Substantive response of the Local Highway Authority to a planning consultation received under The Development Management Order.

Planning Application Number: 24/00769/FUL

Description of Application: Re-consultation. Change of use of land and the siting of 9 single storey holiday lodges with vehicle parking and associated works (Revised Scheme 23/00508/FUL)

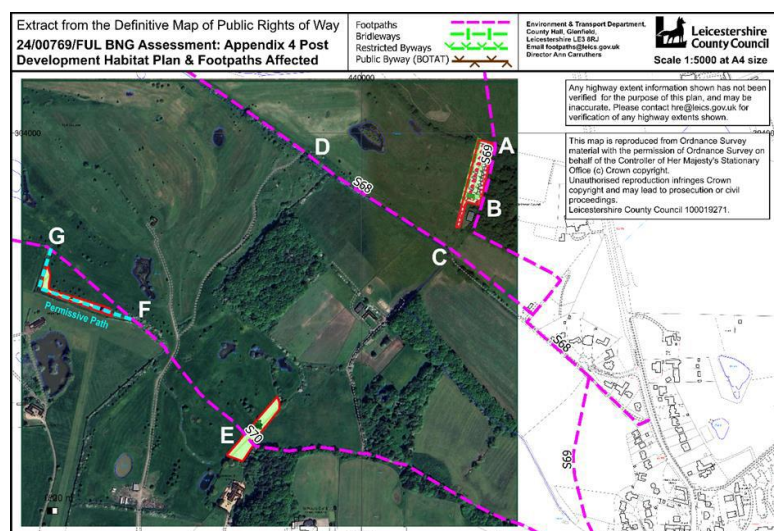
The LHA highlighted within their observations provided to the LPA on 14 May 2025 that the BNG Assessment Habitat Plan proposes mixed scrub planting around point F which appears likely to block or impede the permissive path. That would then mean the banks impeding the Footpath S70 legal alignment could become an enforcement issue. Given this, any habitat creation between points F and G must be consistent with the presence of a footpath created by the landholder for public use. It is a standard requirement of the LHA that no trees or shrubs should be planted within 1 metre of the edge of the public right of way. And that any trees or shrubs planted alongside a public right of way should be of non-invasive species. The observations then went onto state that the planting issue could be addressed easily via amendments to the planting schedule and re-submitted for consideration.

The LHA also stated that the northern lodges area adjoins Footpath S69 though that is on the eastern side of the land boundary between points A and B so should not be affected. Between points C and D, the access track to the lodges follows the same route as Footpath S68 which forms part of the Leicestershire Round long-distance walking trail. The BNG Assessment says the access track is due to be gravelled. However, it needs to be a surface that remains suitable for pedestrians to walk along.

Of the two southern areas for habitat enhancement for BNG purposes, the southeast area, adjoining point E, is crossed by Footpath S70. The BNG enhancement there is to retain the existing modified grassland and this presents few issues for continued use of the public right of way, though clarification is needed on whether the area will be enclosed by fencing, as any additional barrier across a PRoW needs authorisation from the LHA to comply with the Highways Act 1980 section 147.

In the southwestern corner of the golf course, between points F and G, the legally-defined alignment of Footpath S70 is bisected by the golf course's second hole green and surrounding banks. This situation borders on being an unlawful highway obstruction. The situation has been tolerated because a permissive path was provided around the inside edges of the site between these points, as marked in light blue on the plan below.

The LHA proposed to address the planting matter and then impose a condition relating to the treatment of the Public Rights of Way. However, it was stated that it is within the Applicants gift to provide the information for all matters if they should so wish to submit it. However, if the Applicant should wish to discuss either, or both matters, they should contact footpaths@leics.gov.uk.

As such, this does not address all of the matters above relating to the PRowS in terms of planting, surfacing or enclosure.

Given this, these matters remain outstanding, although the LHA are able to secure the surfacing and enclosure via conditions as previously stated.
